Proposal for amendments to ECE/TRANS/WP.29/GRSP/2011/13 (Draft Amendment 2 to global technical regulation No. 9 - Phase 2 (Pedestrian safety))

Note: This document was prepared by the expert from Japan in order to conduct Technical/Editorial amendments. The amendments are supported by Flex-TEG members.

“Figure 17

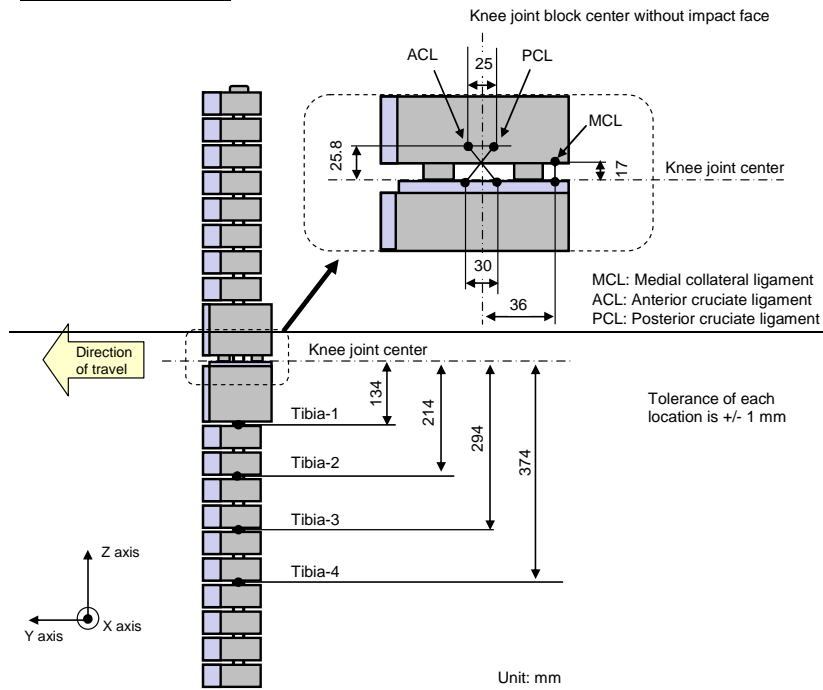
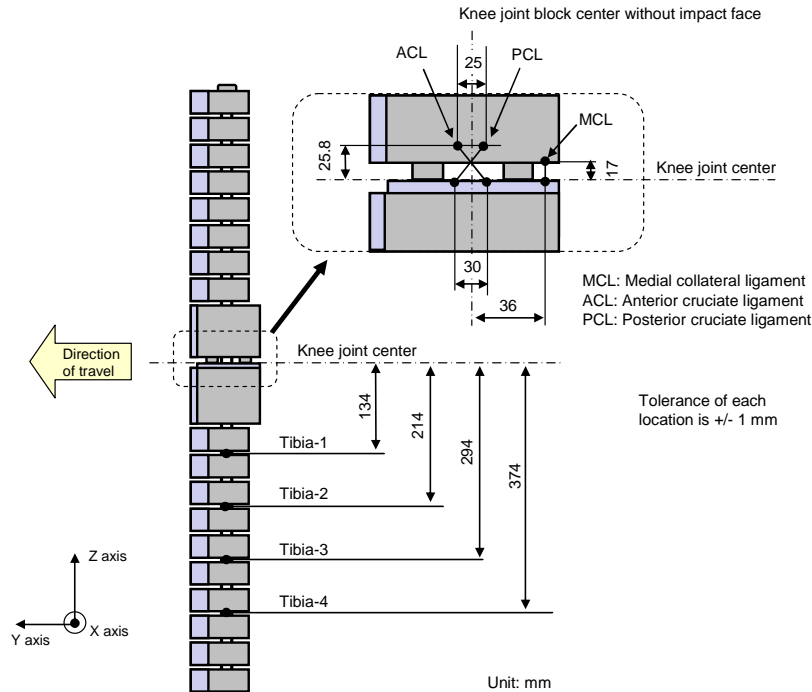
Figure 17., amend to read:

Figure 17 ., Indicated locations are amended (editorial):

Lower legform II; instrument locations

“ Figure 35

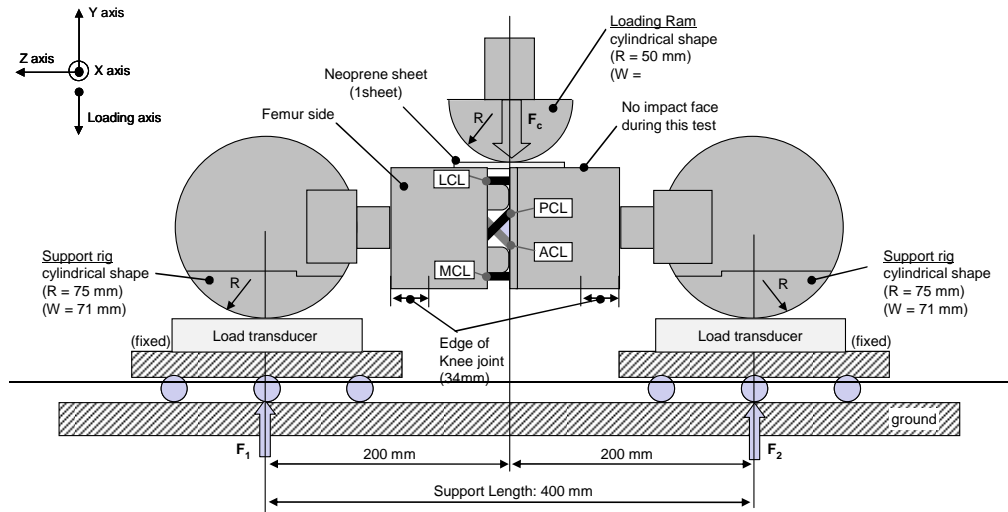
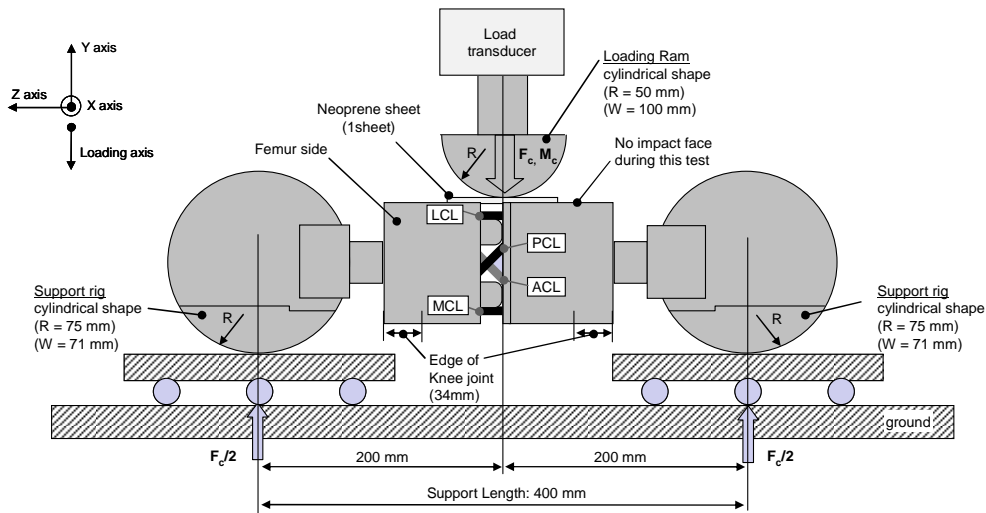
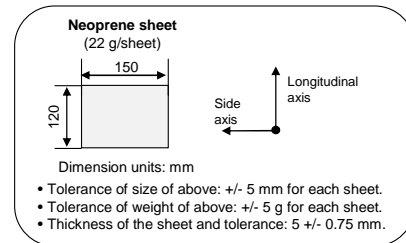
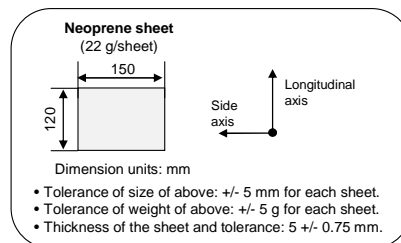
Figure 35 ., amend to read:

Figure 35 ., Load transducer positions and comments are amended/updated (technical):

Lower legform II test set-up for knee joint in static certification test (see paragraph 8.2.1.5.)

F_G : External loading force at center of knee joint
 F_1 : Support force of Femur side of knee
 M_1 : Bending moment at Knee joint center (Nm) = $F_1 \times 0.2$ (m)
 R : Radius, W : Width along to the side axis

F_C : External loading force at center of knee joint
 M_c : Moment center (Nm) = $F_C/2 \times 0.2$ (m)
 R : Radius, W : Width along to the side axis
